## LIST OF PRE-FILED EXHIBITS FOR GAREY REASONABLE USE EXCEPTION

**PLANNING DEPARTMENT**  
**STAFF REPORT**  
**TO CITY OF LAKE FOREST PARK HEARING EXAMINER**

**City File Numbers:** 2021-RUE-0001

**Requested Action:** Approval of reasonable economic use exception from critical area regulations, to construct one single family residence. The proposal also includes construction of utility and access improvements, as well as installation of critical area mitigation.

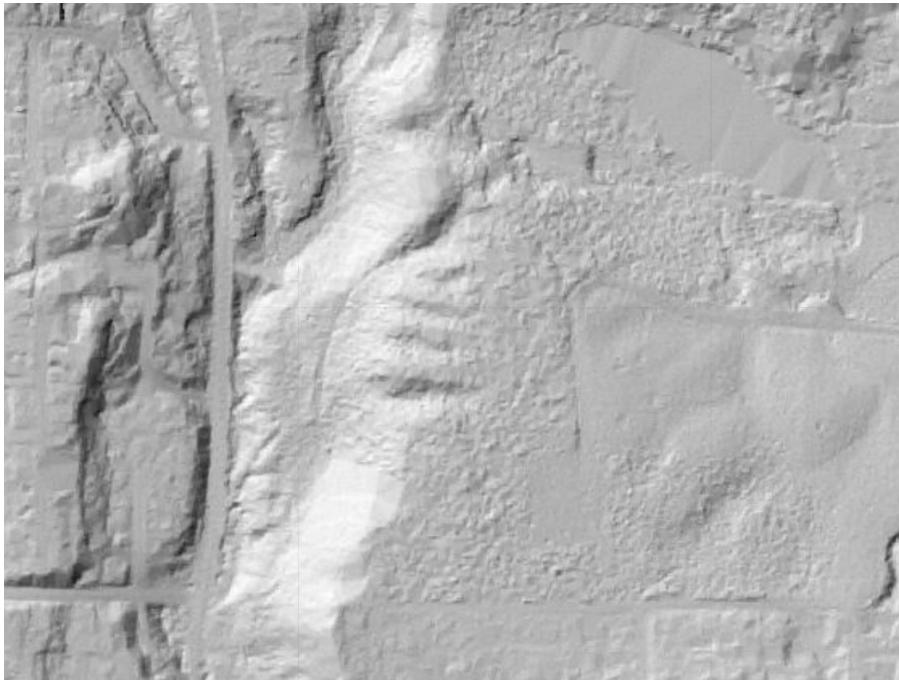
But beyond that and even MORE troubling, is that while the dam is well engineered, on its east side it abuts a steep hill slope that is obviously unstable.

With the constant flooding of the base of that hill (leading up into Brier) there is every reason to expect it will fail at some point. The routine impounding of water at the detention facility in fact undermines the toe of that slope annually. Most relevant however is that should the dam spillway ever get clogged with woody debris at its outfall, resulting in flows diverted to its eastern end, the moving waters there will surely carve a path around the dam in the loose soils there, already wet and so emptying the dam in rapid fashion with water, mud and debris violently pounding its way downstream all the way to Lake Washington no question.

And what happens should a landslide occur anywhere along the pond regardless?

Figure 1 Full size provided as an attachment

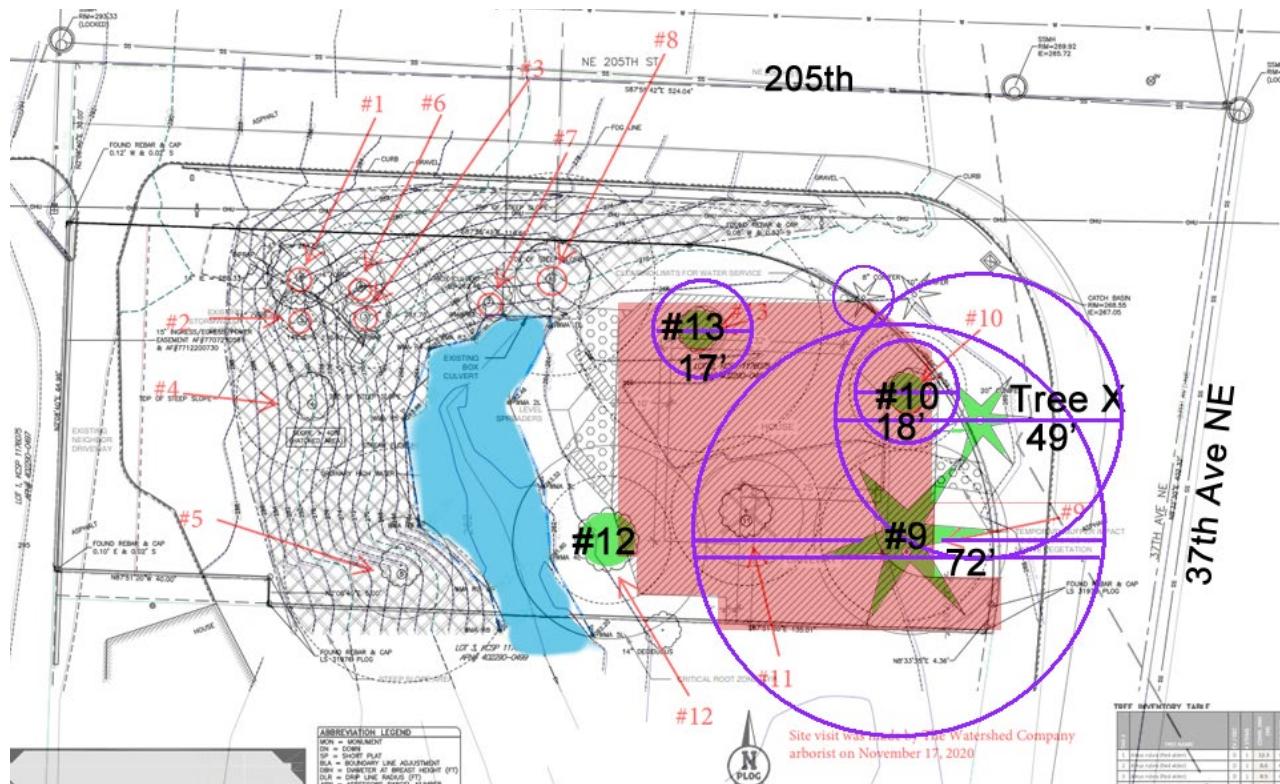
What will happen if trees go missing? Will anyone know? Are there any consequences for saying "only one tree will be removed" but somehow 4 other trees disappear?

Here is the list of inventoried trees on from the document. The ones I am questioning are the significant trees outlined in red and the evergreen that is nameless on the east border on 37th ave. Plus why aren't the other 22 trees on this map.

Figure 4 Parcel and adjacent parcels

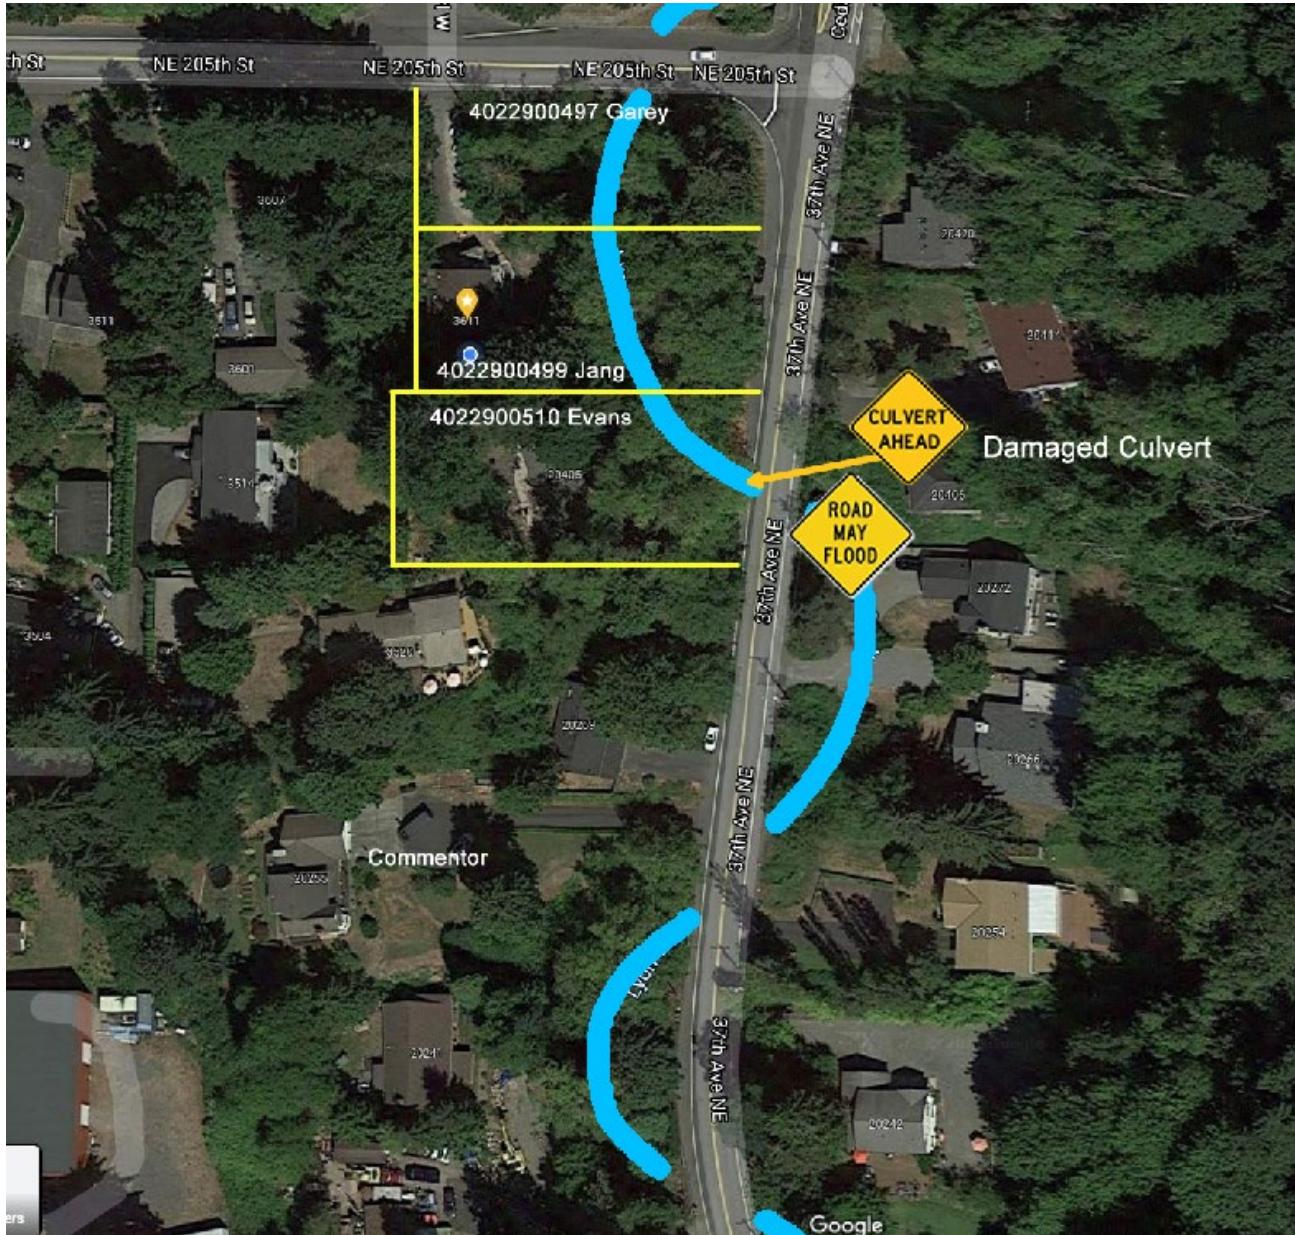
Garey's proposal says "Avoidance: The project avoids direct impacts to Lyon Creek and there will be no less impact that can be done." If you believe it is true, **where is the evidence?**

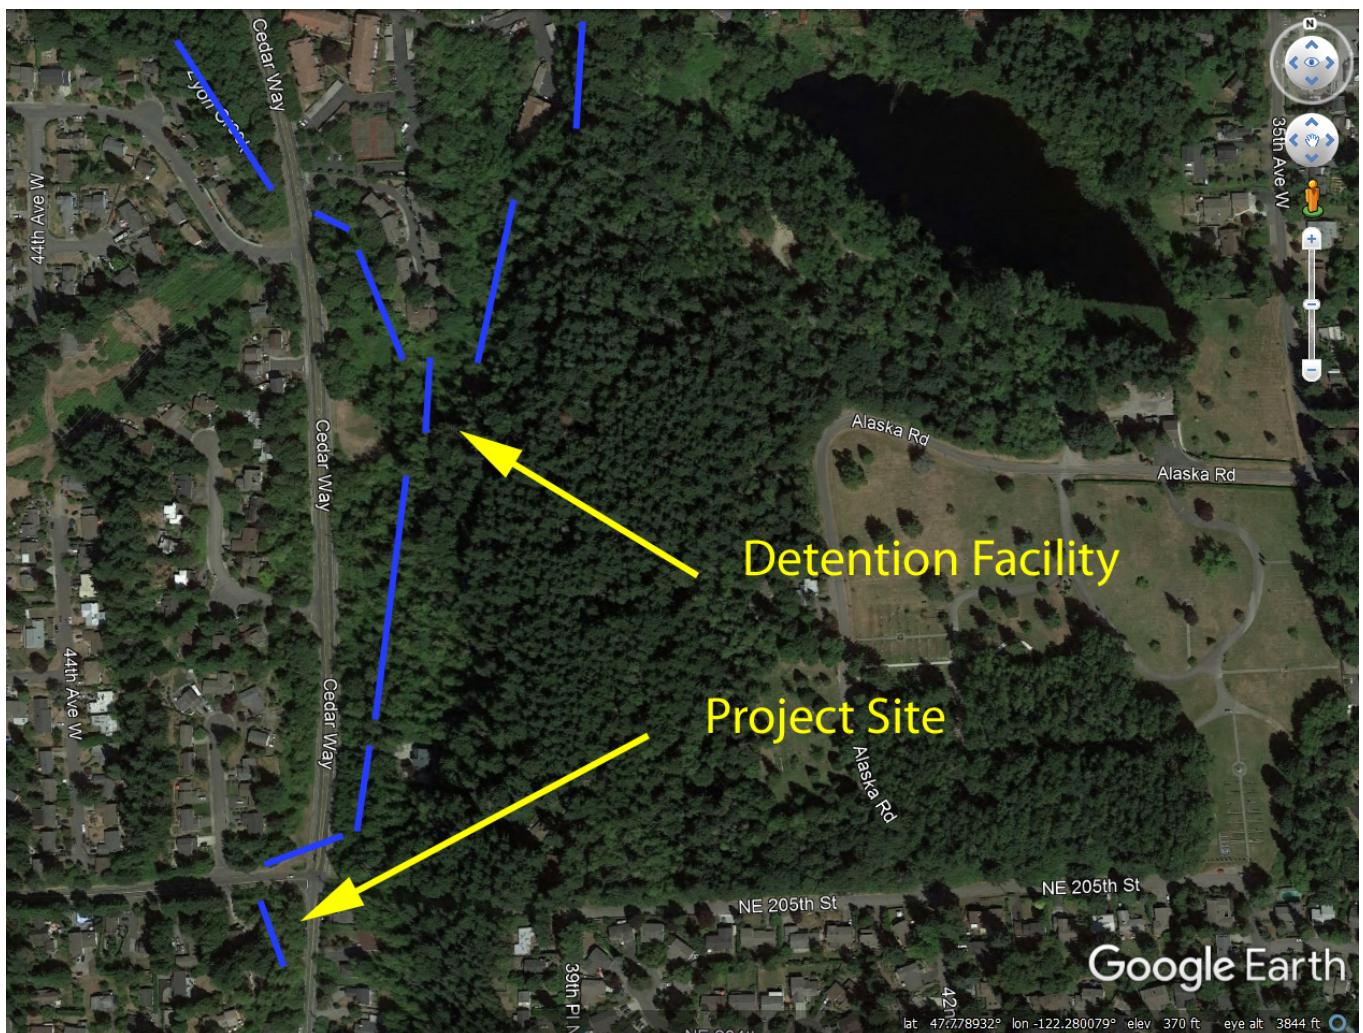
**What about the Evans property and the road flooding?**

**What about the upstream detention pond flooding?**

Photo 2

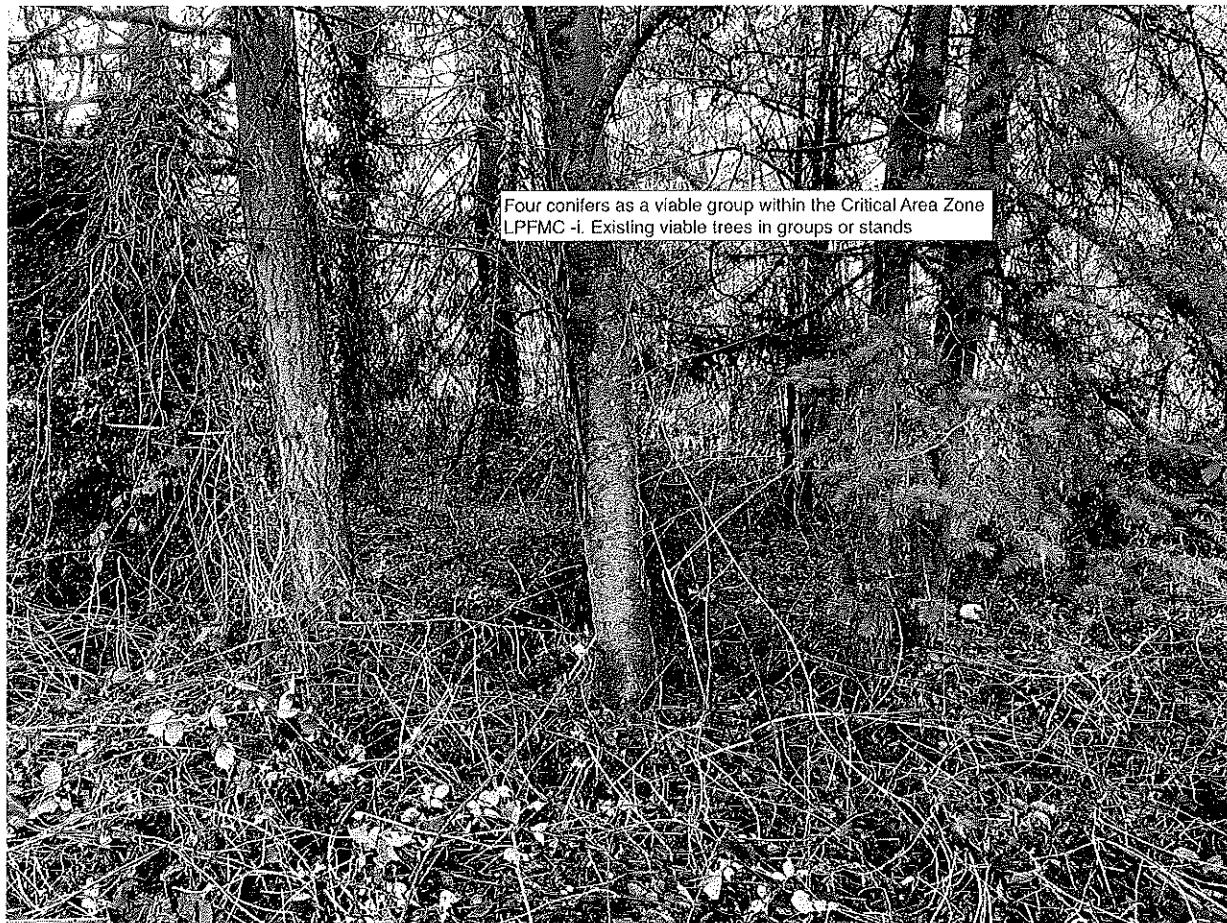
There are several trees on the widened arc of the Public Right of Way including Douglas firs, Sitka spruce and red alders (**see photo 2**). The root zones of these trees forming a grouping would likely be impacted adversely by the clearing limits for water services as identified in Proposed Impacts Assessment W2 of 6. The Report mentions that development proposals shall place a strong emphasis on tree protection LFPMC 16.14.070D as *Tree retention plans shall prioritize i. Existing viable trees in groups or stands.* No mention was given in the Report about what recommendations would be made for these four trees in the Critical Areas Zone of the Public Right of Way.

Photo 3

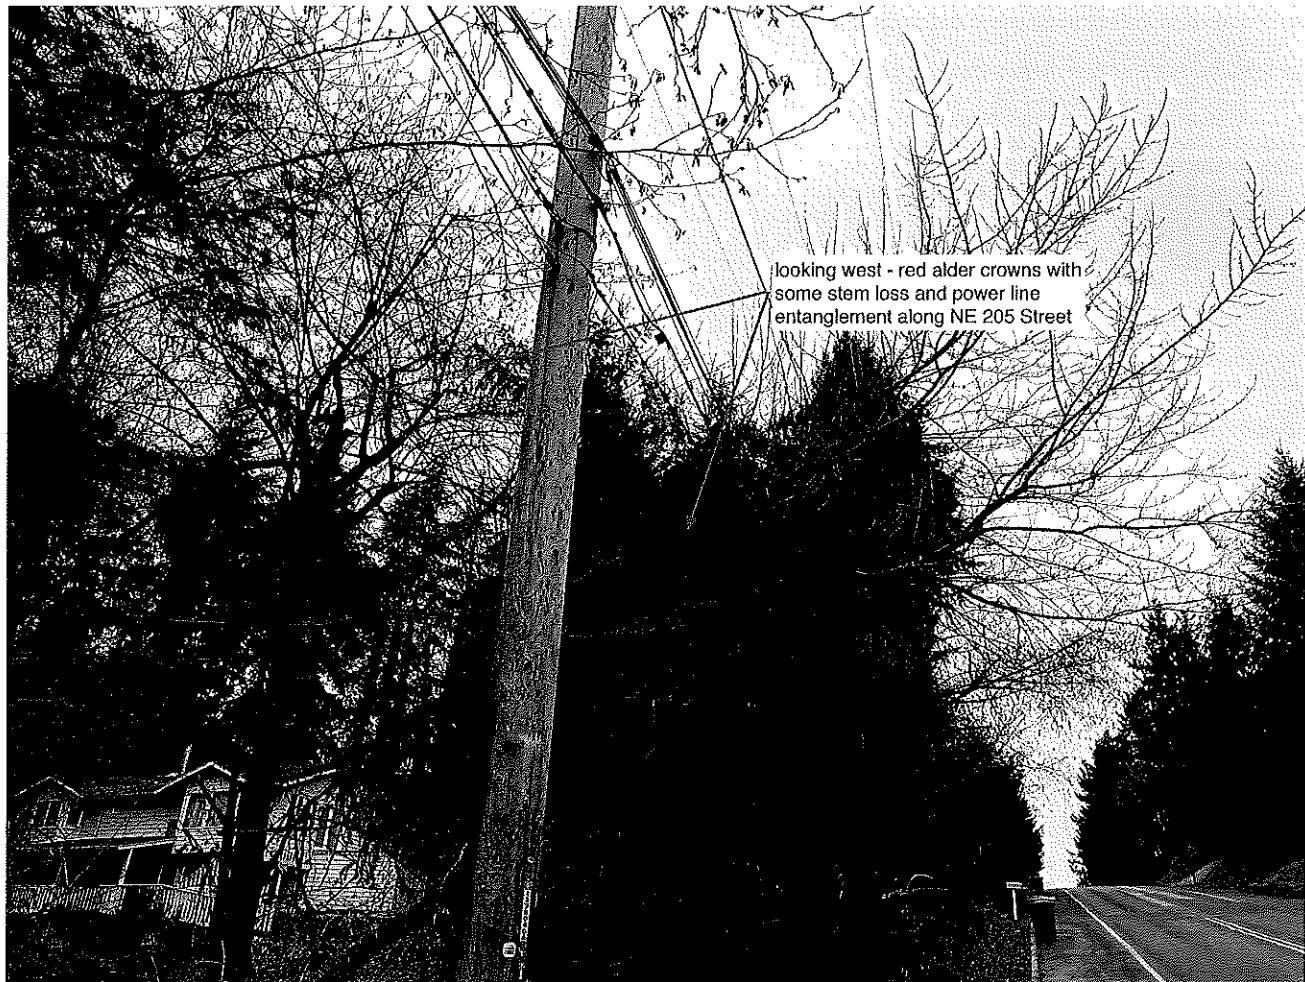
Development of this parcel would remove any meaningful buffer at this location for Lyon Creek and would further degrade the environmental services that the parcels in this reach provide. I observed that the culvert downstream of the property was showing the effects of recent storms, a process that will only be hastened by development of this property (Photo 3).
